Intel Technical Advisory

TA-1047-1

Customers may experience system shutdown and then reboot in power supply redundancy mode when inserting or removing any one of the power supply units, or when system encounters unexpected power supply unit failure.

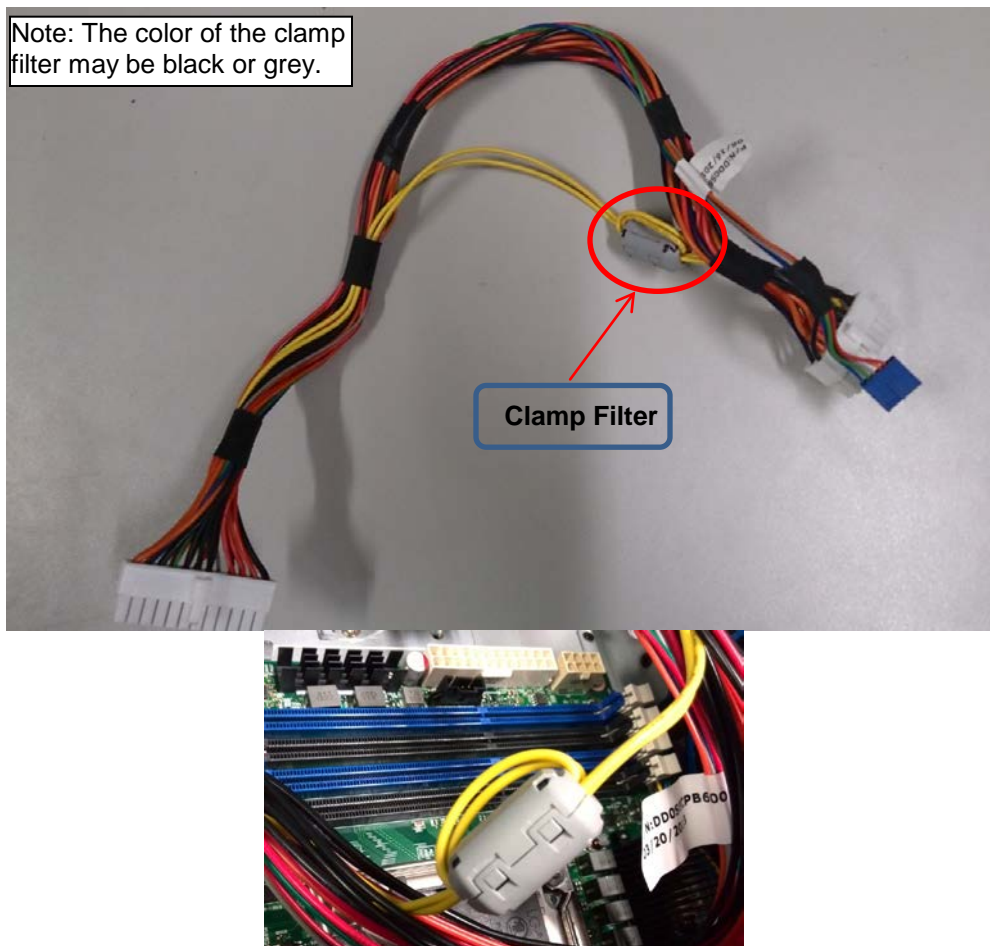
When inserting or removing of one power supply unit, or unexpected power down of any one of the power supply units occurs, the noise from P12V coupled to adjacent signal wires in the same cable bundle may cause the voltage of the remote sense signals to fluctuate beyond their voltage thresholds, and induce the failure of power supply redundancy mode, depending on cable assembly state.

Intel is implementing a clamp filter onto the P12V power wires to fix the issue. For the Intel® Server System P4000IP4 and Workstation System P4000CR2 that have the power supply redundancy function, Intel recommends customers replace the cable set with the clamp filter pre-installed cable.

Please contact Intel using your normal warranty process, indicating that you are calling to replace the cable set regarding TA-1047-1. Having the following information when you call: the serial number(s) of the affected system(s) and the cable part number DD0S6CPB600.
